Device TC1767
Marking/Step EES-AD, ES-AD, AD
Package PG-LQFP-176-5

01704AERRA

This Errata Sheet describes the deviations from the current user documentation.

Figure 1 Timing concerning equidistant multiple timers

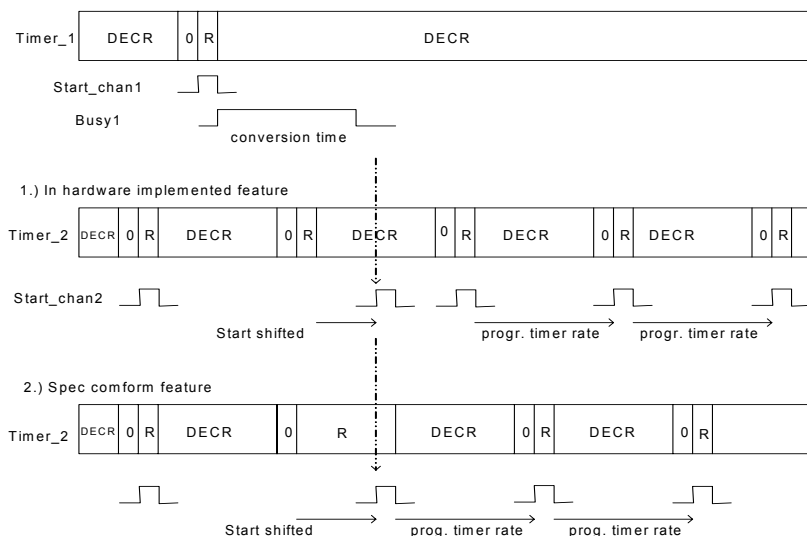
The description is an example for timer_1 and timer_2, but can also affect all other combinations of timers.

Timer_1 and Timer_2 are running with different reload-values. Both timers should start conversions with the requirement of equidistant timing.

Problem description:

Timer_1 becomes zero and starts a conversion. Timer_2 becomes zero during this conversion is running and sets the conversion-request-bit of channel_2. At the end of the conversion for channel_1 this request initiates a start for channel_2. But the Timer_2 is reloaded only when setting the request-bit for channel_2 and is decremented during the conversion of channel_1.

The correct behavior would be a reload when the requested conversion (of channel_2) is started.

Therefore the start of conversion for channel_2 is delayed by maximum one conversion-time. After this delay it will be continued with equidistant conversion-starts. Please refer to the following figure.

**Figure 2 Loss of Arbitration**

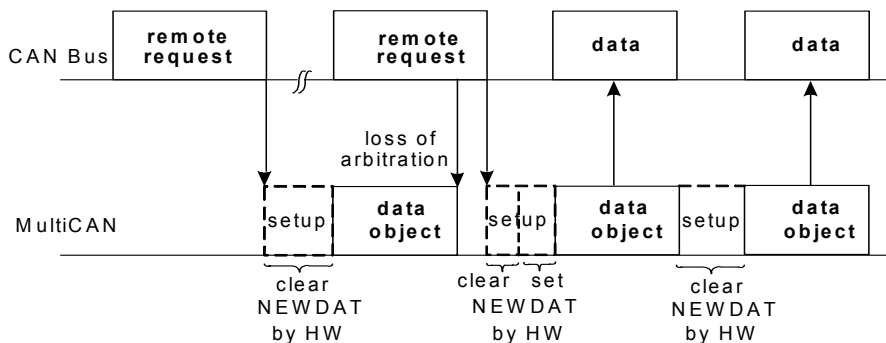
When the appropriate message object (data frame) triggered by the first remote frame wins the arbitration, it will be sent out and NEWDAT is not reset. This leads to an additional data frame, that will be sent by this message object (clearing NEWDAT).

There will, however, not be more data frames than there are corresponding remote requests.
